Access Compliance Report

Public Rights-of-Way

(Curb Ramps)

Intersection ID: 3863	Main Street: CHIPSTONE_RD	Cross Street: COPPERPLATE_RD	Location:	NW
ADA ID: 174008128800	Ramp Type: Perp	Initial Pass/Fail: Fail	Overall Compliance: No	Severity Score: 25
Codes/Mitigation Info/Possible Solution		Field Measurements/Component Compliance

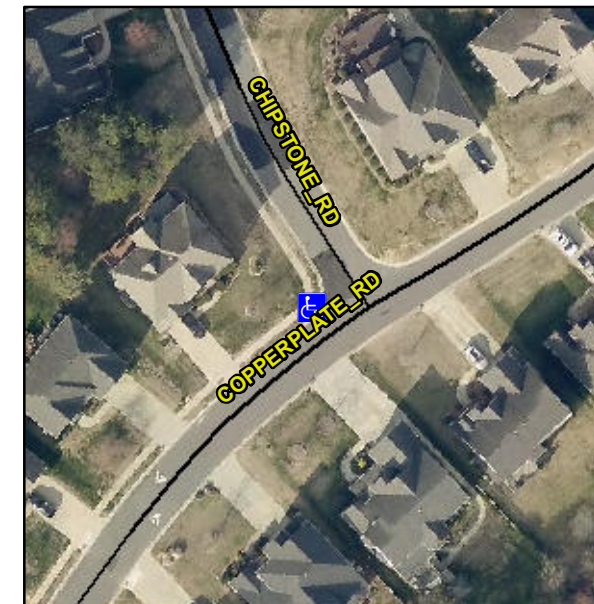
Not Found, R304.2.2, R304.5.3

Compliance	Description	Data	Compliance	Description	Data
N/A	Ramp Length (in)	46.0	No	Ramp Slope (%)	8.9
Yes	Ramp Width (in)	48.0	No	Ramp XSlope (%)	6.8
N/A	Flare Type LT	N/A	N/A	Flare Type RT	N/A
N/A	Flare Slope LT (%)	N/A	N/A	Flare Slope RT (%)	N/A
N/A	Flare Traversable LT?	N/A	N/A	Flare Traversable RT?	N/A
N/A	Landing Length (in)	N/A	N/A	DWS Provided?	N/A
N/A	Landing Width (in)	N/A	N/A	DWS Contrast?	N/A
N/A	Landing Slope (%)	N/A	N/A	DWS Length (in)	N/A
N/A	Landing X Slope (%)	N/A	N/A	DWS Full Width?	N/A
N/A	Landing Curb? (Y/N)	N/A	N/A	DWS Offset (in)	N/A
N/A	Shared Landing?	N/A			
N/A	Gutter Ponding?	N/A	N/A	Gutter Slope (%)	N/A
N/A	Gutter Lip Ht (in)	N/A	N/A	Gutter X Slope (%)	N/A
N/A	Painted X Walk1?	No	N/A	Painted X Walk2?	N/A
	X Walk 1 Direction	To S		X Walk 2 Direction	N/A
N/A	X Walk 1 Width (in)	N/A	N/A	X Walk 2 Width (in)	N/A
	X Walk 1 Slope (%)	3.6		X Walk 2 Slope (%)	N/A
	X Walk 1 X Slope (%)	1.4		X Walk 2 X Slope (%)	N/A

Remove & Replace Entire Ramp.
